Owner: JUAN Alears Phone # 799-7916  
 Address: 20 Ramble Rd- Cape Elizabeth, ME 04107  
 LOCATION OF CONSTRUCTION 12 Deering St.  
 Contractor: Hap Cleary Sub.: 799-7916  
 Address: Box 6608 - Ptld, ME Phone # 04101  
 Est. Construction Cost: \$800 Proposed Use: 1-fam dwlg w intr renov  
 Past Use: 1-fam  
 # of Existing Res. Units \_\_\_\_\_ # of New Res. Units \_\_\_\_\_  
 Building Dimensions L \_\_\_\_\_ W \_\_\_\_\_ Total Sq. Ft. \_\_\_\_\_  
 # Stories: \_\_\_\_\_ # Bedrooms \_\_\_\_\_ Lot Size: \_\_\_\_\_  
 Is Proposed Use: Seasonal \_\_\_\_\_ Condominium \_\_\_\_\_ Conversion \_\_\_\_\_  
 Explain Conversion Interior renovations - closet; 2nd fl

BUILDING PERMIT REPORT

Address 12 Deering St. Date 19/Jun/94  
Reason for Permit to make interior renovations -  
Close 2nd floor Bldg. Owner: Jean Ahearne  
Contractor: Hap Cleary  
Permit Applicant: \_\_\_\_\_  
Approval: \*4 \*18

SECTIONAL VIEW THROUGH STAIRWELL

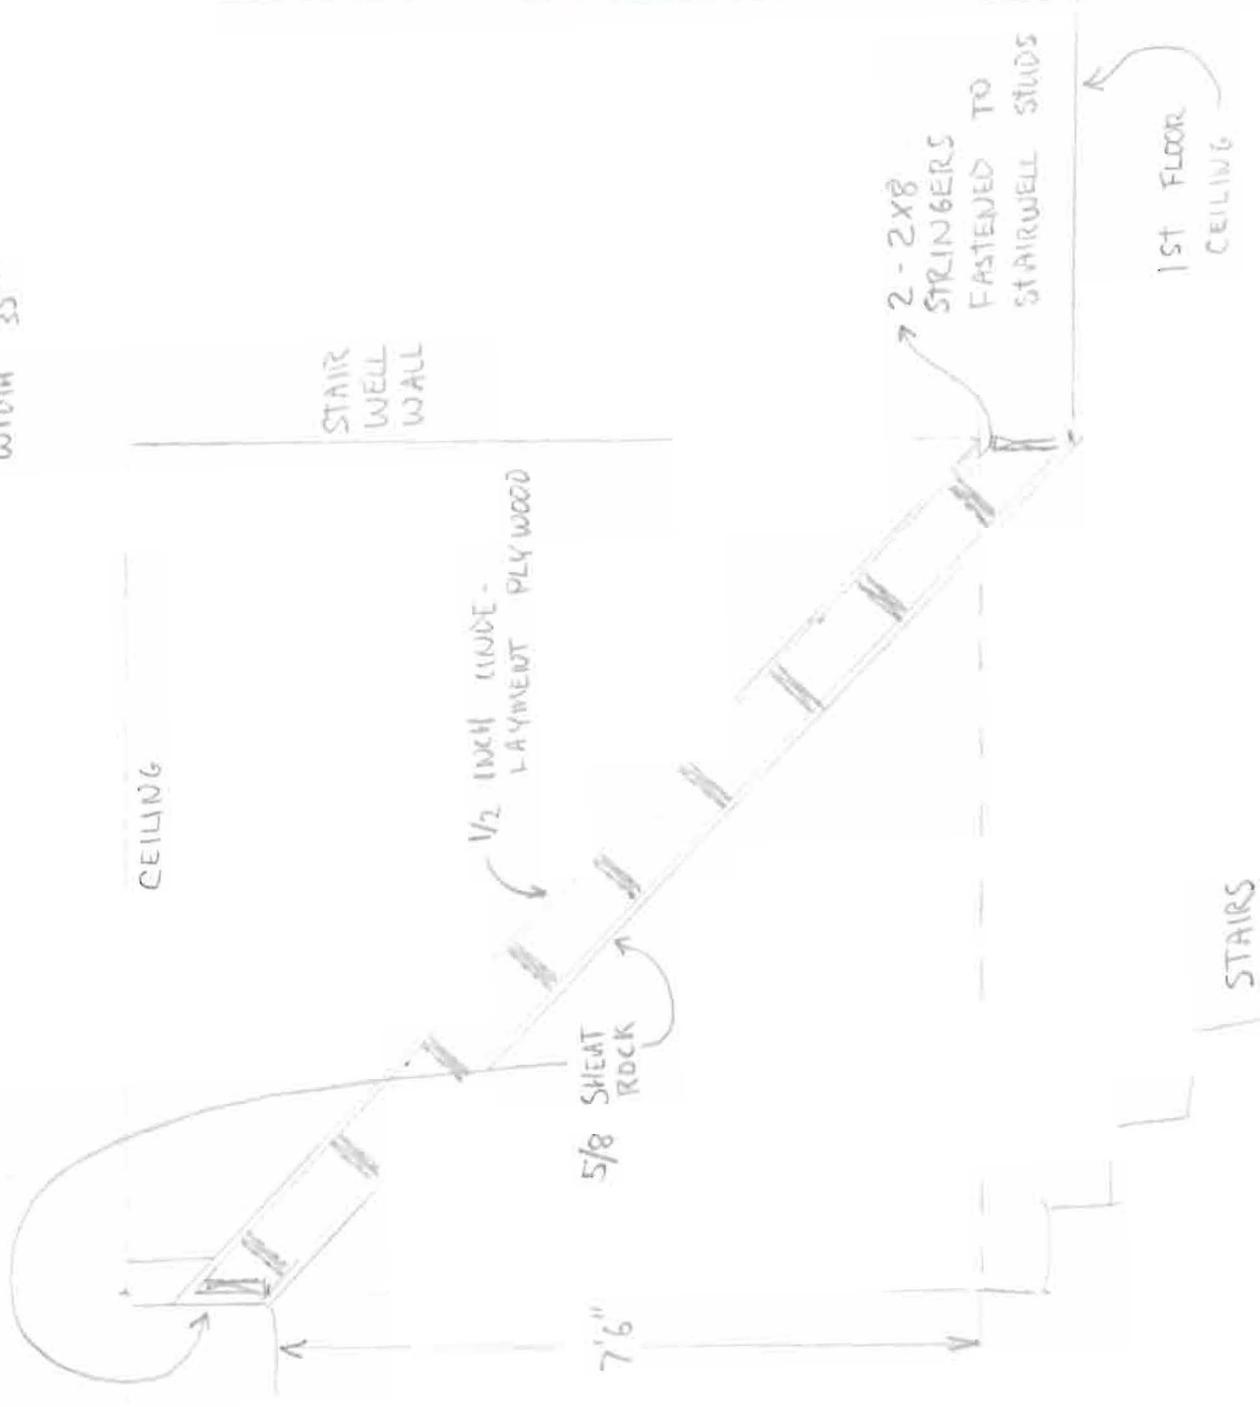
- \*4. All vertical openings shall be enclosed with construction having a fire rating of at least one (1) hr., including fire doors with selfclosers.
5. Each apartment shall have access to (2) separate, remote and approved means of egress. A single exit is acceptable when it exits directly from the apartment to the building exterior with no communications to other apartment units.

18. NO EXTERIOR WORK IS TO BE DONE
